**TECHNICAL DRAINAGE STUDY ADDENDUM FOR
LINDELL LIVING 2
SECTION 01, TOWNSHIP 21 SOUTH, RANGE 60 EAST
CITY OF LAS VEGAS, NEVADA**

**Re: Technical Drainage Study for Lindell Living II
Application No.: DS5495A**

The following is our response to the comments and conditions of approval placed on the above-referenced project. In a memorandum dated September 30, 2021, City of Las Vegas expressed concern about the following items:

FIGURE 10

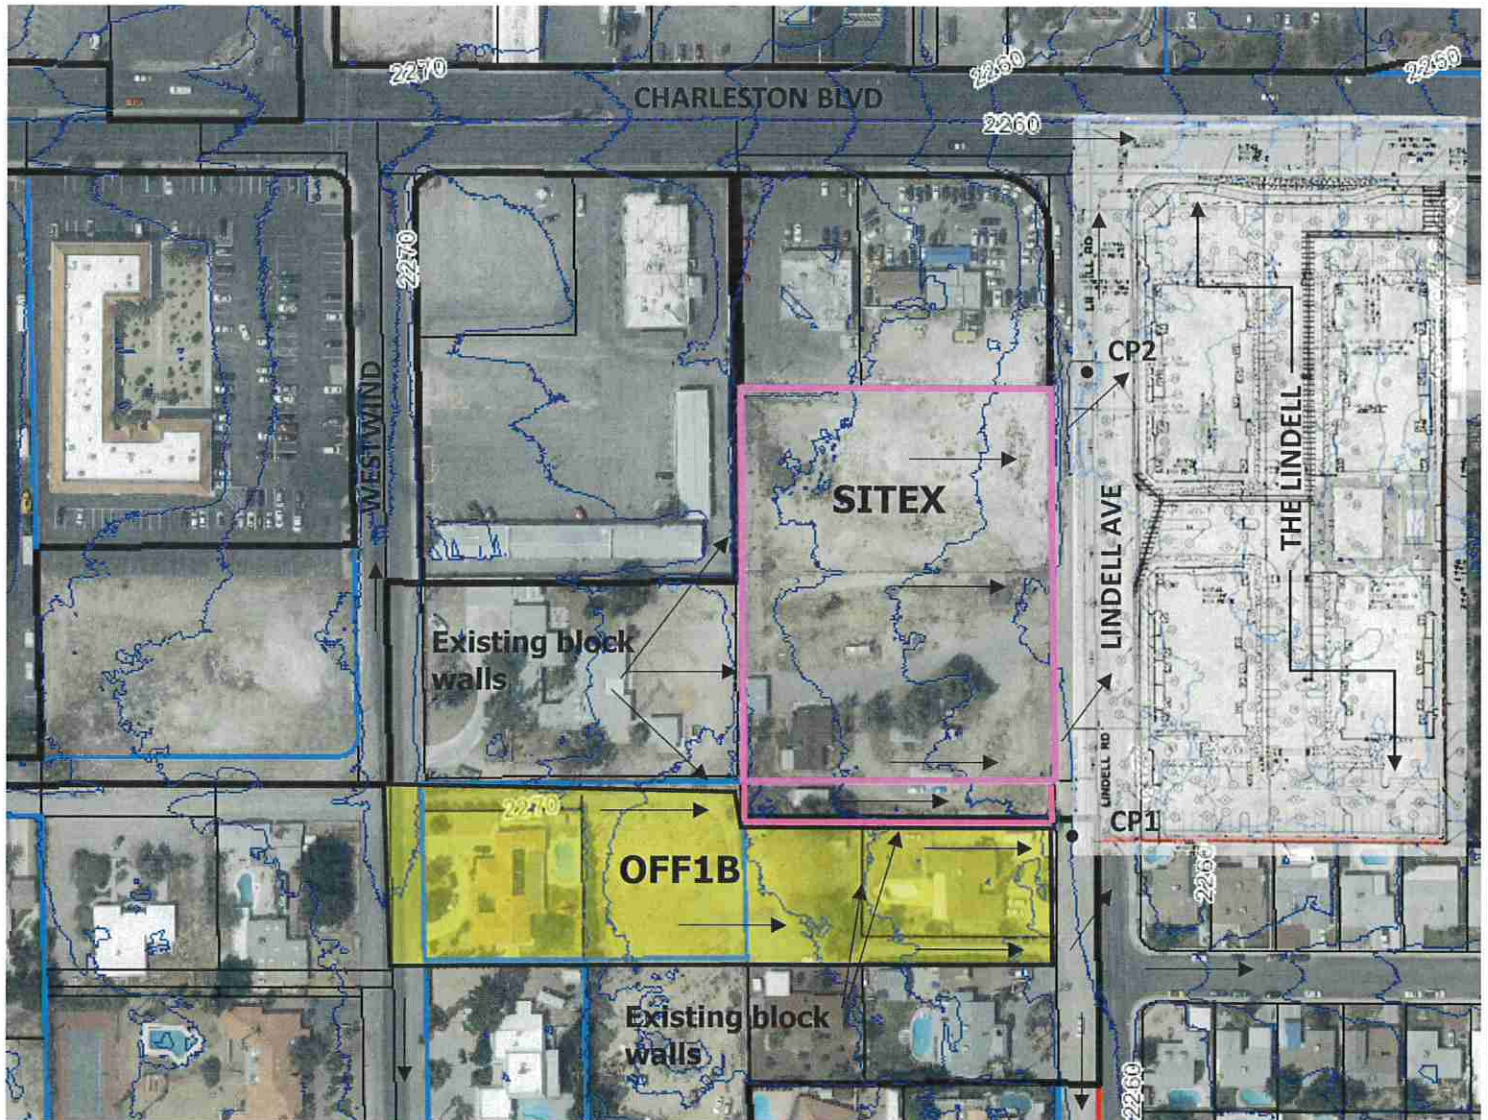
Comment No. 2: FIG 11 (Existing Onsite Basin Map): It is not clear how the area of the offsite basins (OFF1A, OFF1B, etc) are determined. Revise the map to show the entirety of the offsite basins. The reviewer cannot conclude that the offsite basins are limited to the stated areas and Q10/Q100 as shown in the drainage map. Clearly address the methodology of determining the offsite basin impacting the subject site.

Response: Figure 11 is the Existing Onsite Basin Map is not intended to show the offsite basins in their entirety. Figure 10 is the Offsite Basin Map and shows the delineation of the offsite basins.

From the approved drainage study for The Lindell, it was determined that the offsite basin extended west to Westwind, therefore, the parcels between Westwind and Lindell become the area contributing flow toward the site and Lindell. However, an existing block wall lies along the majority of the west property line blocking flows from entering the site from the west (Basin OFF1A which has been removed, See Appendix B for revised calculations). A block wall also lies along the easterly 2/3 of the south property line. A gap in the block wall west of APN 163-01-103-010 may allow flows to enter the site here. It is assumed that all the flows associated with the offsite basins make their way to Lindell.

OFF1B is associated with APNs 163-01-103-007, 008, 010 and a portion of 009. Existing contours indicate that this basin drains due east toward Lindell.

All the offsite flows reach Lindell and travel north to Charleston Blvd. A pair of drop inlets at the entrance to The Lindell will collect about 5 cfs of the street flows. This existing storm drain system will carry the collected runoff in a 24-inch RCP through The Lindell site. This pipe discharges to an outlet structure along the north side of The Lindell property line to Charleston. This flow discharges via a series of existing sidewalk under drains.
